From: Becky-Coel Roback [becky_cr@lanl.gov]
Sent: Friday, November 03, 2006 2:16 PM
To: 'Dhawan, Neelam, NMENV'
Cc: 'Becky-Coel Roback'
Subject: Revisions to the Upper LA investigation work plan NOD response
Attachments: Upp_LA_NOD_rev1.pdf

Oral Communication Record

Revised Response to the "Notice of Disapproval for Investigation Work Plan for the Upper Los Alamos Canyon Aggregate Area, Los Alamos National Laboratory EPA ID No: NM0890010515, HWB-LANL-06-012," Dated August 22, 2006

Figure 3.2-1. SWMU 00-017 site map and proposed sampling locations

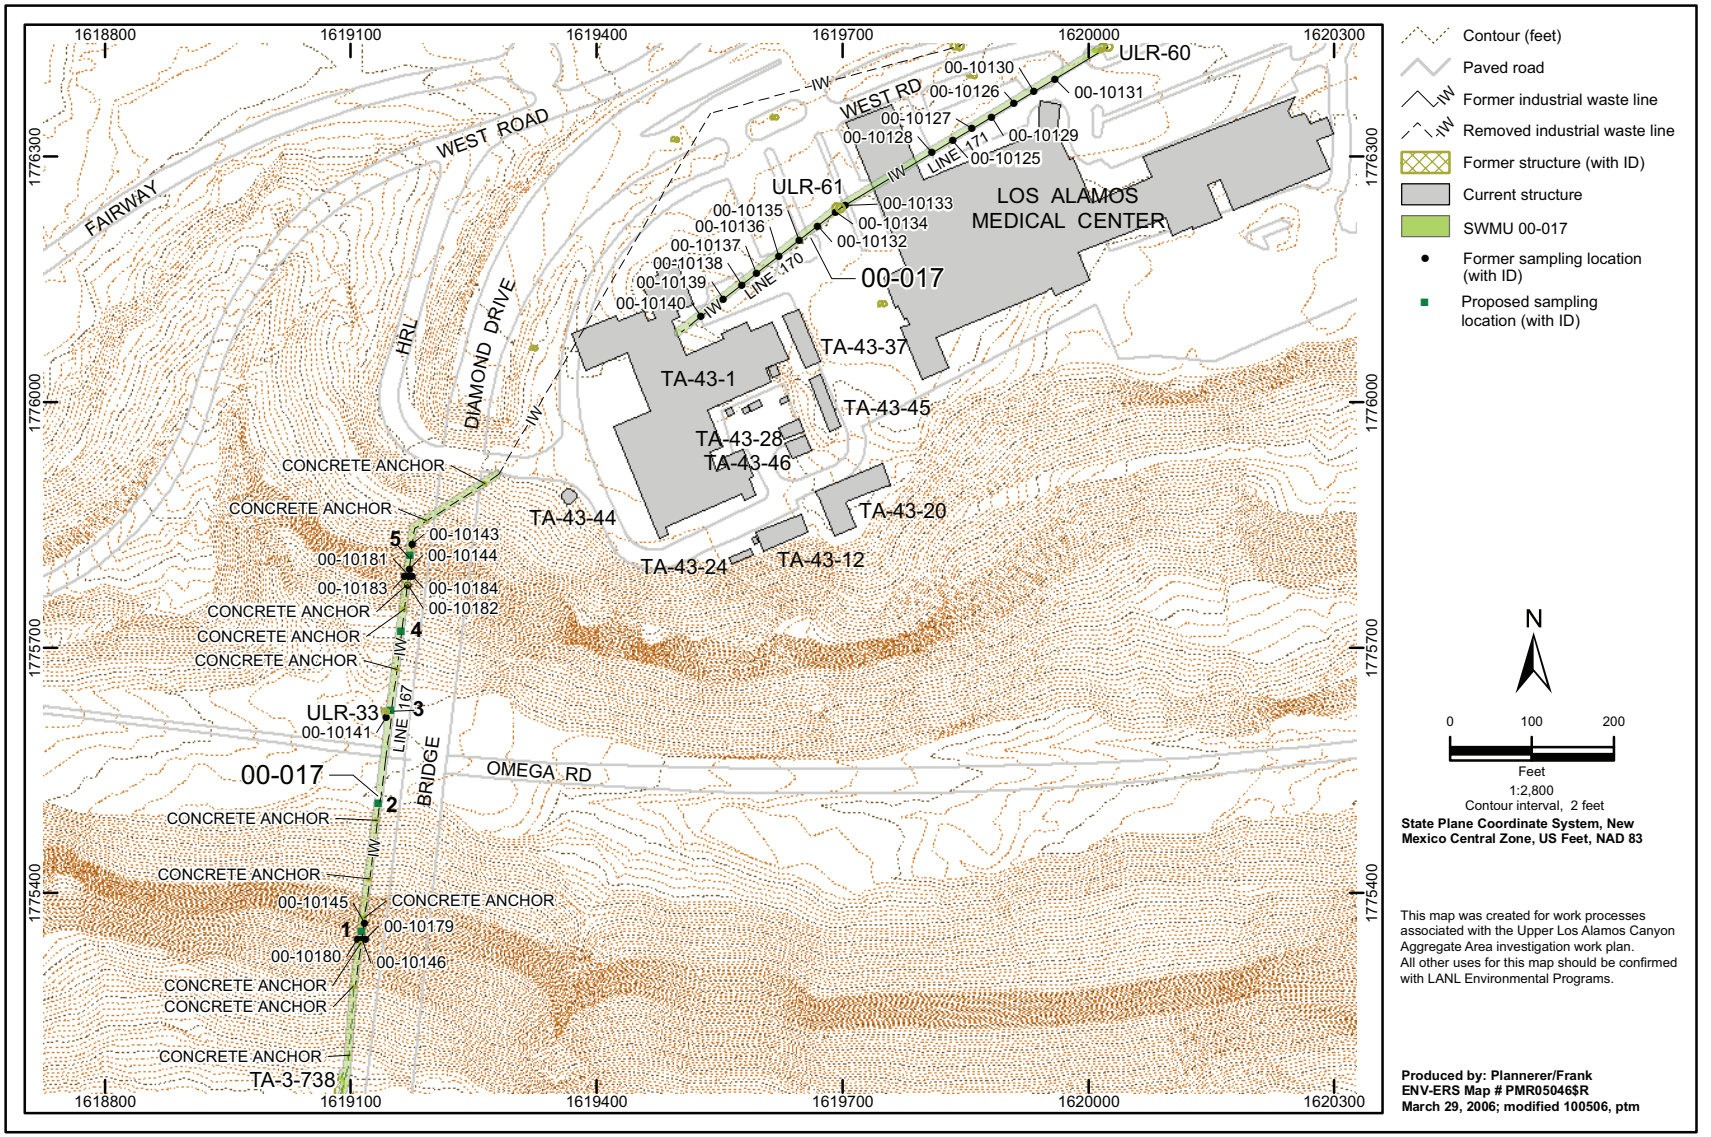
(1) LANL response to NMED specific comment #3 includes revised text to the work plan. The revised text was not updated to include sample location 00-10125. A revised version of the NOD response is included with this record of communication (ROC).

RFI report for SWMU 00-017 (LANL 1999, 64029) reports 45 samples from 29 locations were analyzed at off-site laboratory not 40 samples from 26 locations as reported in the WP. Resolve the discrepancy and revise the WP and HIR accordingly.

The three samples collected from the trackhoe bucket (RE00-98-0051, -0052, and -0053, all from the mesa top) should have been included in the work plan because valid location coordinates are available for location 00-10125.

The revised work plan text follows, and the revised table (Table 3.1-1) and figure (Figure 3.2-1) are included in Attachments 2 and 3, respectively.

Samples analyzed at off-site fixed laboratories included 43 soil, fill, sediment, and tuff samples collected from 27 locations at SWMU 00-017 (Figure 3.2-1, Table 3.1-1). Samples from the 11 locations (00-10141, 00-10143 through 00-10146, and 00-10179 through 00-10184) at former line 167 were collected from depths of 0.1 to 9 ft. Samples from the 16 locations at line 170 and line 171 (00-10125 through 00-10140) were collected from depths of 12.5 to 27.5 ft, depending on the depth of the pipe. The suites analyzed for each sample are provided in Table 3.1-1.

Figure 6.3-1. SWMU 32-002(a) site map and proposed sample locations

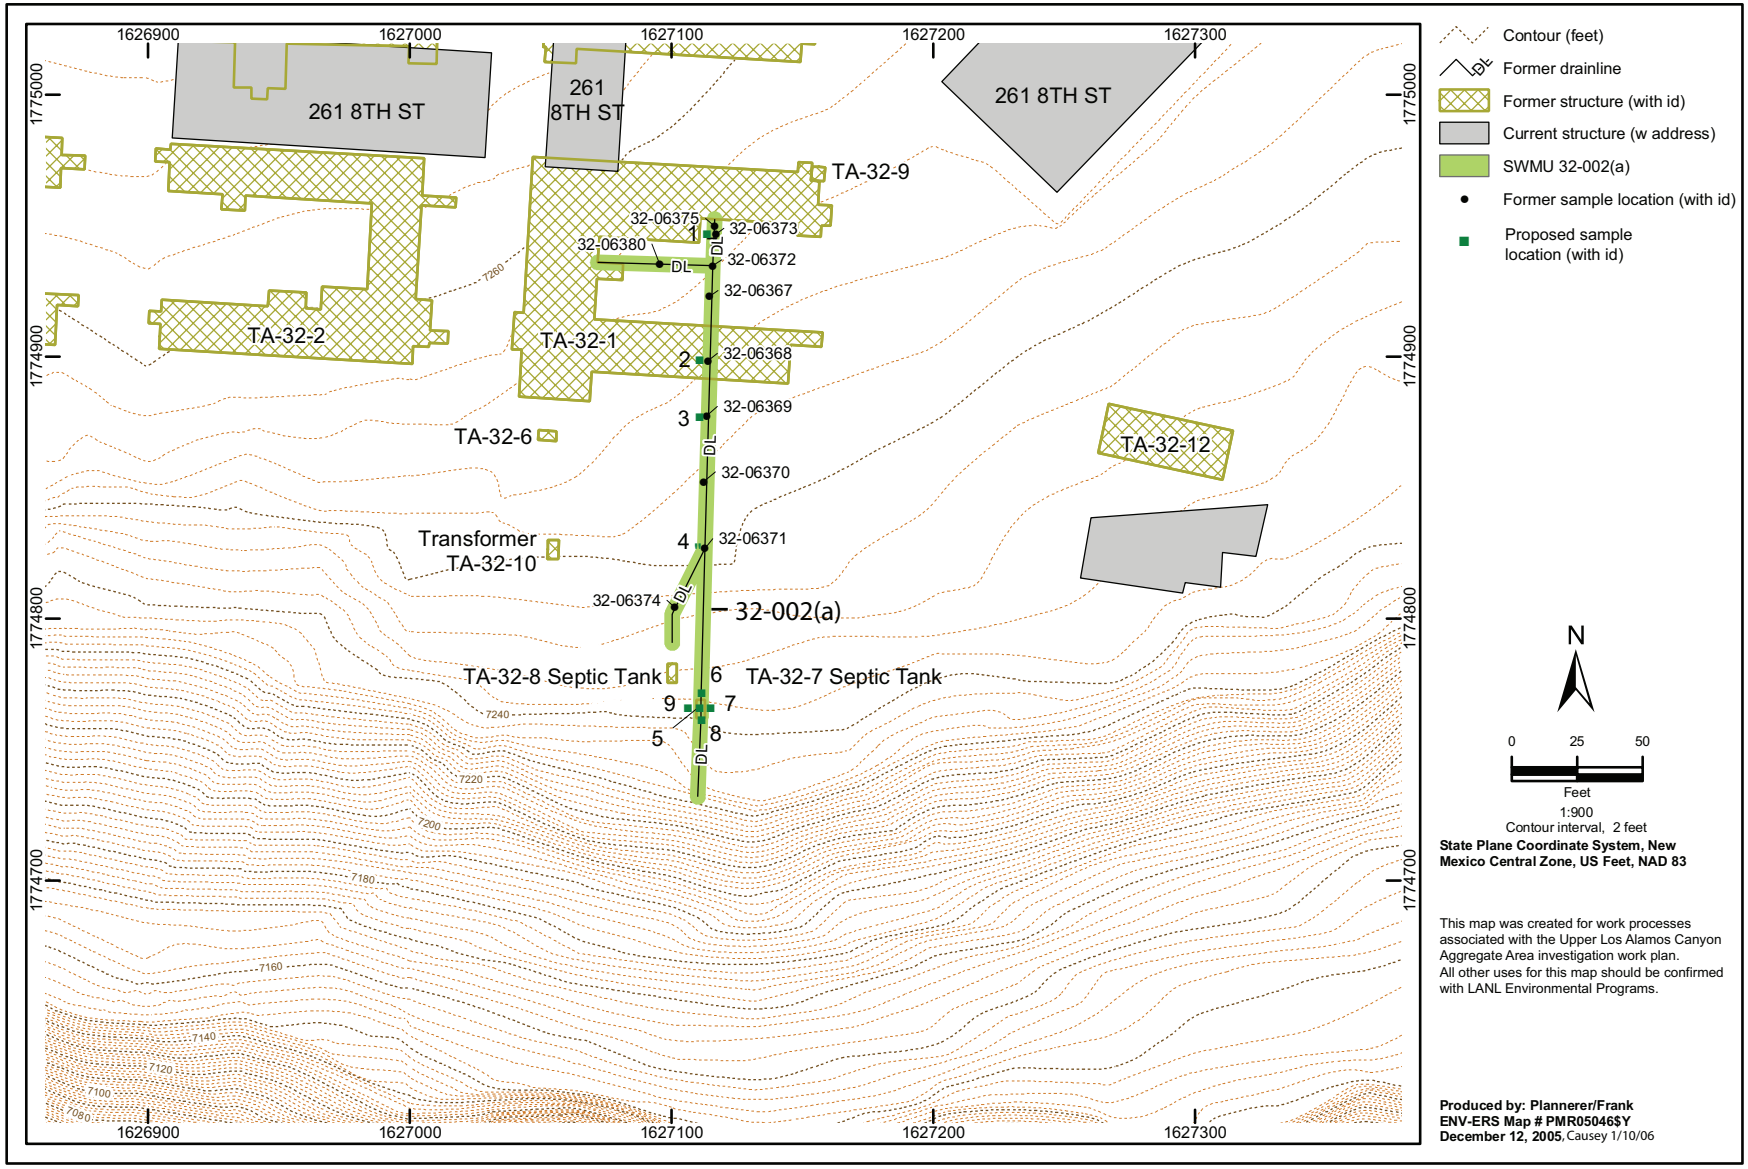
(3) LANL response to NMED specific comment #17 included a revised table and figure. Location 32-06368, which was included in the original work plan, was inadvertently left off the revised figure and table. The corrected Figure 6.3-1 and Table 6.3-1 are included with this ROC. Also, Neelam noted that some of the sample depths had been changed. These changes were made to correct inconsistencies between the text and the tables in the investigation work plan.

17. Proposed sample 1 has been moved next to previous sampling location 32-06373 instead of 32-06375. The revised work plan text follows, and the revised table (Table 6.3-1) and figure (Figure 6.3-1) are included in Attachments 2 and 3, respectively.

The proposed sampling locations at SWMU 32-002(a) are shown in Figure 6.3-1. Table 6.3-1 provides a summary of the proposed sampling locations, depths, the objective of each sample, and the proposed analytical suites. Sampling at SWMU 32-002(a) will consist of the following activities:

- *Drain Line.* Previous samples were collected at only one depth at each location. Therefore, to determine extent, deeper sampling is proposed. Samples will be collected immediately adjacent to previous sampling locations 32-06373 (the location of the highest lead and mercury concentrations), 32-06368, 32-06369 (the location of the second highest lead and mercury concentrations), and 32-06371 (the location of highest concentrations of plutonium-239 and PAHs) (Figure 6.3-1, locations 1 through 3, respectively). Samples will be collected from the 0- to 1.0-ft and 2.0- to 3.0-ft-depth intervals. Zero depth is defined as immediately beneath the bed of the previously excavated pipe. Care will be taken that debris containing parking lot material or asphalt is not included in the sample.
